# UNITED STATES PATENT AND TRADEMARK OFFICE

APPLICATION NO.	FILING DATE	FIRST NAMED INVENTOR	ATTORNEY DOCKET NO.	CONFIRMATION NO.
09/748,277	12/27/2000	Jac-Lag Ma	8733.363.00	4729
30827	7590	09/07/2005		
MCKENNA LONG & ALDRIDGE LLP 1900 K STREET, NW WASHINGTON, DC 20006			EXAMINER RUDE, TIMOTHY L	
			ART UNIT 2883	PAPER NUMBER
DATE MAILED: 09/07/2005

## Office Action Summary

Fig. 1

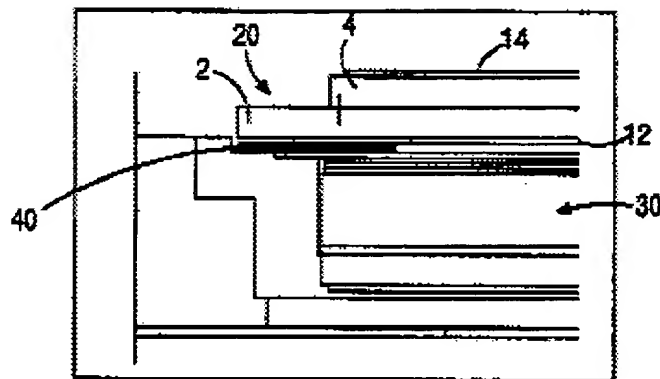
As to claims 6 and 9-12, APA discloses in Figures 1-4 (Specification pages 2-4), a dot matrix (Specification, Page 2, lines 18-22) liquid crystal display (LCD) device, comprising:

an upper polarizer, 14; on an upper substrate, 4;

a lower substrate, 4, on a lower polarizer, 12;

a liquid crystal layer (not shown) disposed between the upper substrate and the lower substrate; and

a backlight device, 30, disposed opposite and adjacent to the lower polarizer for emitting light toward the lower polarizer (Figure 1) (please note that adjacent does not preclude structures between those items considered to be adjacent, e.g., two houses may be adjacent despite the existence of an intervening garage);

wherein at least a black pad, 40, that acts as a light shield (Applicant's light shielding layer) formed in a rectangular shape having a substantially centrally located rectangular opening resulting in light shielding layer substantially shielding exclusively the peripheral portion (evident from Specification, Page 3, lines 11-14) of the lower polarizer to permit light to pass through the rectangular opening; wherein the light shielding layer only blocks a portion of the light traveling to four peripheral sides of the lower polarizer for minimizing constructive interference at a peripheral portion of the LCD device; and wherein the light shielding film absorbs light (inherent property of the color black).

APA does not explicitly disclose a lower polarizer that includes said light shielding film.
